STAFF REPORT 10-08-2025 REGULAR MEETING

APPLICATION NUMBER: HDC2025-00593

ADDRESS: 808-816 VIRGINIA PARK

SCOPE: ERECT TWO ATTACHED DUPLEX BUILDINGS (14 UNITS TOTAL)

Site plan (above) and perspective rendering (next page) from the applicant's submission materials. The buildings will be faced in a mix of traditional brick and cement panels, as depicted below.

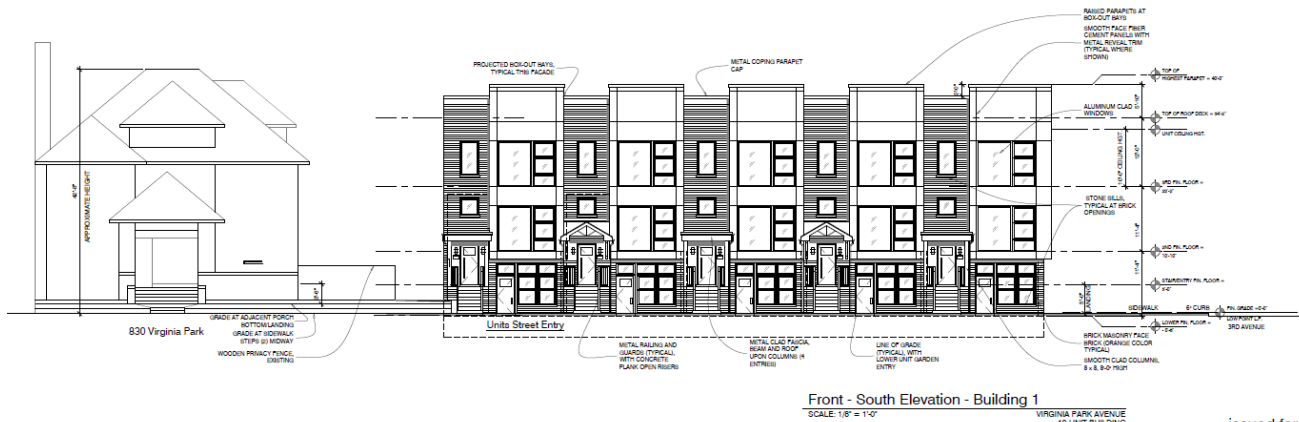
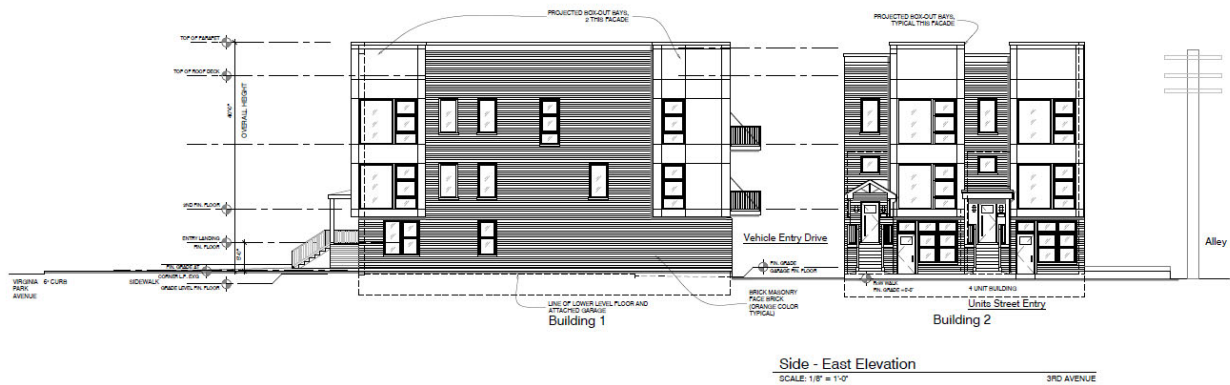
- **HDC Staff analysis:** The applicant characterizes the cement panels as “siding.” Staff disagrees. Unlike the brick, cement panels with metal reveal trim are not reasonably

related to a historic material precedent on Virginia Park Avenue. While modern materials on new construction in historic districts are often used successfully in small doses (as accents), especially when they can be traced to a historic use, the extensive use of modern panels on these proposed buildings makes them the default primary expression and substantially at odds with the historic context. Staff acknowledges the introduction of additional wood features at the porches, but this element is failed. See also Element 8, below.

- **HDC Staff analysis:** Staff agrees that flat roofs are appropriate to the contemporary style of the proposed building; however, flat roofs are not compatible with the existing character of Virginia Park, which is universally marked by pitched and complex roof forms of various types. Contemporary design, as suggested in Element 10 above, is flexible enough to incorporate complex geometries and intricate details while staying true to a modern “style.” Though the introduction of traditional roof forms at the porches does explicitly acknowledge historic prototypes, this element is still failed.

Proposed (rendered) view along Virginia Park given above. The current view is seen in staff photo below, taken on May 30, 2025.

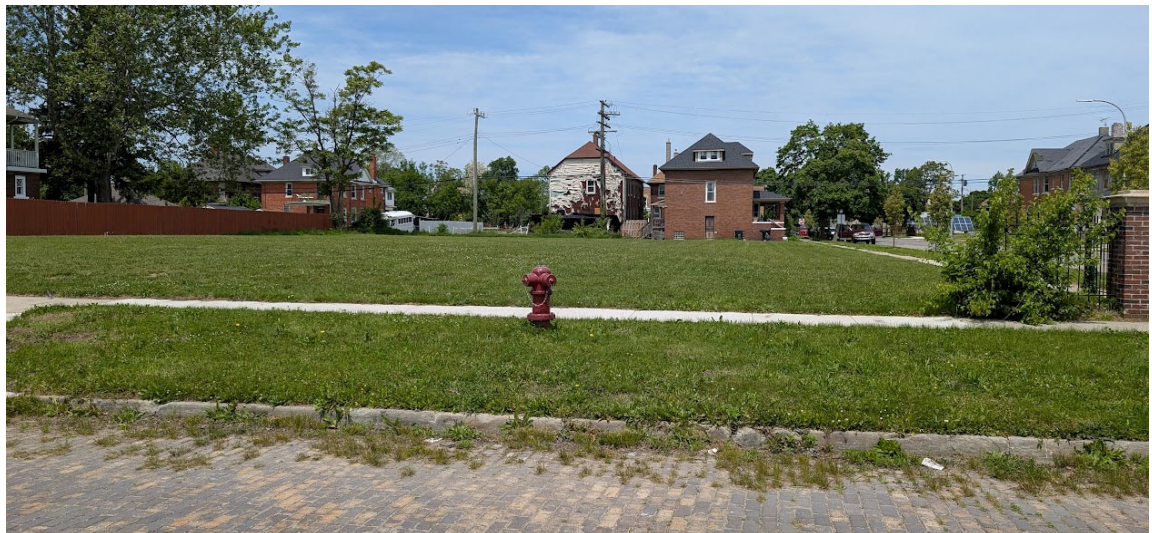
- *The casement and awning windows shown before were replaced with a more traditional single-hung window.*
- Of the Commission’s reasons given for Denial numbered above, staff assesses that the revised design does not successfully address them, excepting maybe slightly more complexity in support of reasons #5

and #10 by the addition of the garden units and porch roofs, though not fully. As discussed in our original historic analysis from the February report, mostly reproduced verbatim below, a large multi-family or attached dwelling-style development project is quite unlikely to meet historic standards, given the stark difference in massing, scale, and character between such a development and the historic 2½ story single-family dwellings. This appears to leave a “Notice to Proceed” as the only viable approval path. Such a decision requires the Commission to find that the inappropriate work serves a substantial community benefit, among other possible provisions.
